SERVICE BULLETIN REVISION NOTICE

ENGINE — LP COMPRESSOR — REPLACEMENT OF SEVERAL RINGS TO REDUCE OIL LEAKS Turbojet Engine Service Bulletin No. V2500-ENG-72-0701 Revision No. 1 dated March 8, 2021.

ENGINE — LP COMPRESSOR — REPLACEMENT OF SEVERAL RINGS TO REDUCE OIL LEAKS

V2500-ENG-72-0701

LOCATION OF THE RING 72-32-00 FIGURE 1

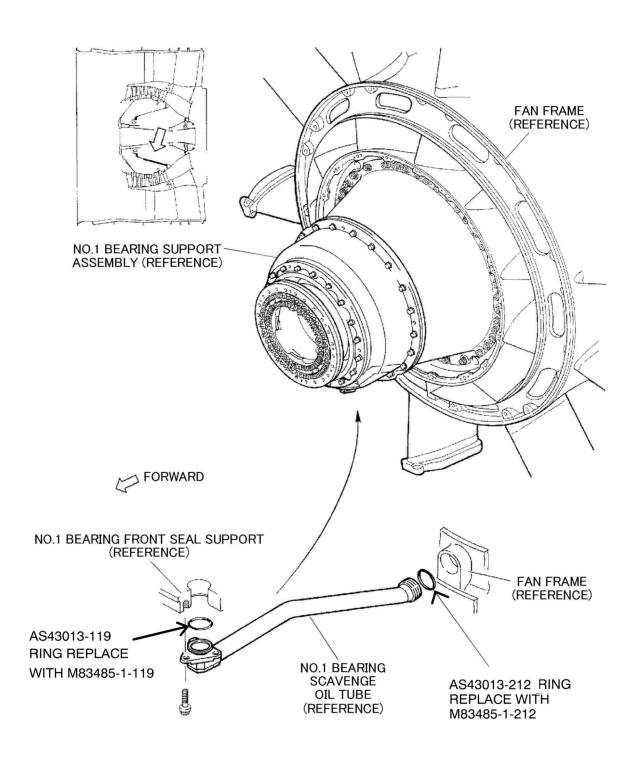
- Replace the rings as follows:
 - A. Replace ring, PN AS43013-212 with PN M83485-1-212. Reference 7, Engine Manual, TASK 72-32-00-030-005, Disassembly-005 and 72-32-00-430-011, Assembly-011. Refer to Figure 1.

- 1. Replace the rings as follows:
 - A. Replace ring, PN AS43013-212 with PN M83485-1-212. Reference 8, Engine Manual, TASK 72-32-00-030-005, Disassembly-005 and 72-32-00-430-011, Assembly-011. Refer to Figure 1.

LOCATION OF THE RINGS 72-32-00 FIGURE 2

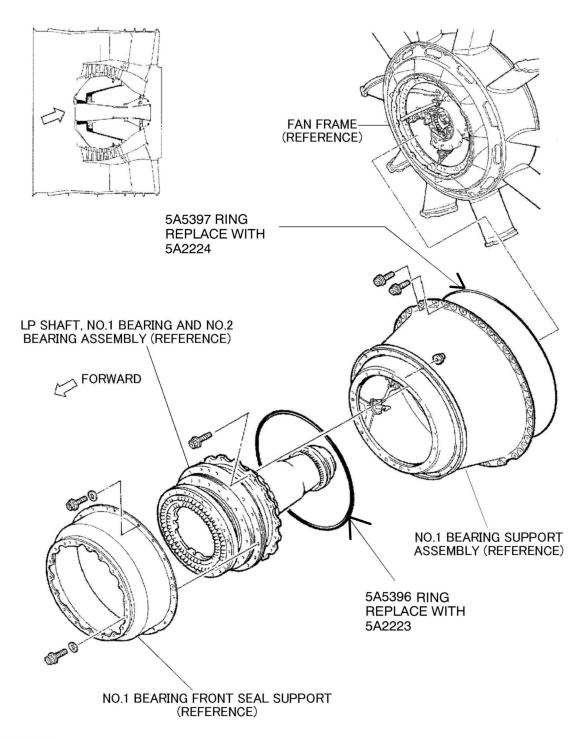
- B. Replace ring, PN AS43013-119 with PN M83485-1-119. Reference 7, Engine Manual, TASK 72-32-00-030-009, Disassembly-009 and 72-32-00-430-007, Assembly-007. Refer to Figure 2.

- C. Replace ring, PN AS43013-212 with PN M83485-1-212. Reference 7, Engine Manual, TASK 72-32-00-030-009, Disassembly-009 and 72-32-00-430-007, Assembly-007 Refer to Figure 2.

- B. Replace ring, PN AS43013-119 with PN M83485-1-119. Reference 8, Engine Manual, TASK 72-32-00-030-009, Disassembly-009 and 72-32-00-430-007, Assembly-007. Refer to Figure 2.

- C. Replace ring, PN AS43013-212 with PN M83485-1-212. Reference 8, Engine Manual, TASK 72-32-00-030-009, Disassembly-009 and 72-32-00-430-007, Assembly-007 Refer to Figure 2.

LOCATION OF THE RINGS 72-32-00 FIGURE 3

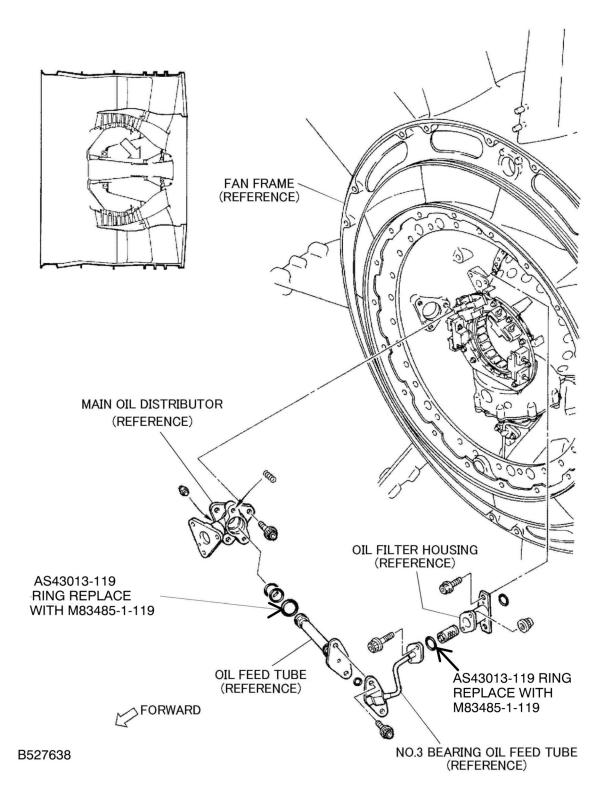
- D. Replace ring, PN 5A5396 with PN 5A2223. Reference 7, Engine Manual, TASK 72-32-00-030-009, Disassembly-009 and 72-32-00-430-007, Assembly-007 Refer to Figure 3.

- E. Replace ring, PN 5A5397 with PN 5A2224. Reference 7, Engine Manual, TASK 72-32-00-030-013, Disassembly-013 and 72-32-00-430-003, Assembly-003. Refer to Figure 3.

- D. Replace ring, PN 5A5396 with PN 5A2223. Reference 8, Engine Manual, TASK 72-32-00-030-009, Disassembly-009 and 72-32-00-430-007, Assembly-007 Refer to Figure 3.

- E. Replace ring, PN 5A5397 with PN 5A2224. Reference 8, Engine Manual, TASK 72-32-00-030-009, Disassembly-009 and 72-32-00-430-007, Assembly-007. Refer to Figure 3.

LOCATION OF THE RINGS 72-32-36 FIGURE 4

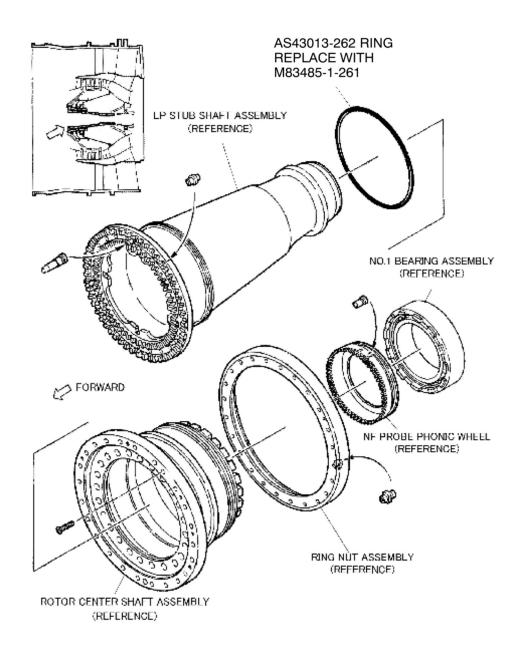
- F. Replace ring, PN AS43013-119 with PN M83485-1-119. Reference 7, Engine Manual, TASK 72-32-00-030-012, Disassembly-012 and 72-32-00-430-004, Assembly-004. Refer to Figure 4.

- G. Replace ring, PN AS43013-119 with PN M83485-1-119. Reference 7, Engine Manual, TASK 72-32-00-030-014, Disassembly-014 and 72-32-00-430-002, Assembly-002. Refer to Figure 4.

- F. Replace ring, PN AS43013-119 with PN M83485-1-119. Reference 8, Engine Manual, TASK 72-32-00-030-012, Disassembly-012 and 72-32-00-430-004, Assembly-004. Refer to Figure 4.

- G. Replace ring, PN AS43013-119 with PN M83485-1-119. Reference 8, Engine Manual, TASK 72-32-00-030-014, Disassembly-014 and 72-32-00-430-002, Assembly-002. Refer to Figure 4.

LOCATION OF THE RING 72-32-51 FIGURE 5

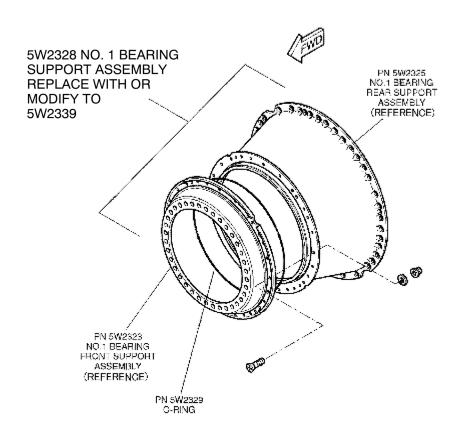
- H. Replace ring, PN AS43013-262 with PN M83485-1-261. Reference 7, Engine Manual, TASK 72-32-50-040-001, Disassembly-001 and 72-32-50-440-001, Assembly-001 Refer to Figure 5.

- H. Replace ring, PN AS43013-262 with PN M83485-1-261. Reference 8, Engine Manual, TASK 72-32-50-040-001, Disassembly-001 and 72-32-50-440-001, Assembly-001 Refer to Figure 5.

LOCATION OF THE NO. 1 BEARING SUPPORT ASSEMBLY AND RING (V2500-A1 AND V2500-A5 ONLY)

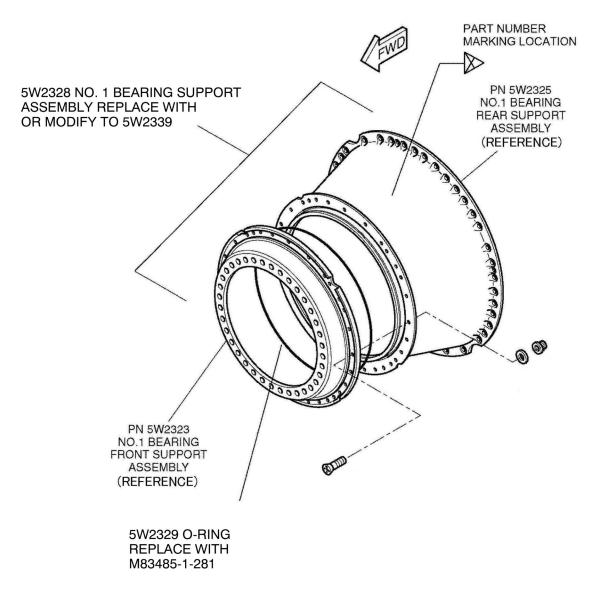
- 2. Rework instructions for No.1 bearing support assembly. Refer to Figure 6.
 - A. Disassemble the No.1 Bearing Support Assembly for Post SBE 72-0391 configuration parts. Reference 7, Engine Manual, TASK 72-32-41-040-001, Disassembly-001.

- B. Replace the ring, PN 5W2329 with PN M83485-1-281.
 - C. Install the new ring, PN M83485-1-281 to the No.1 Bearing Support Assembly. Reference 7, Engine Manual, TASK 72-32-41-440-001, Assembly-001.

- D. Re-identify the part adjacent to existing part number per Table 1. Cross off the existing part number with a double line. Mark the new part number per Reference 3, Standard Practices Manual, Chapter/Section 70-09-00, marking of parts. Use vibropeen method (manual or mechanical).
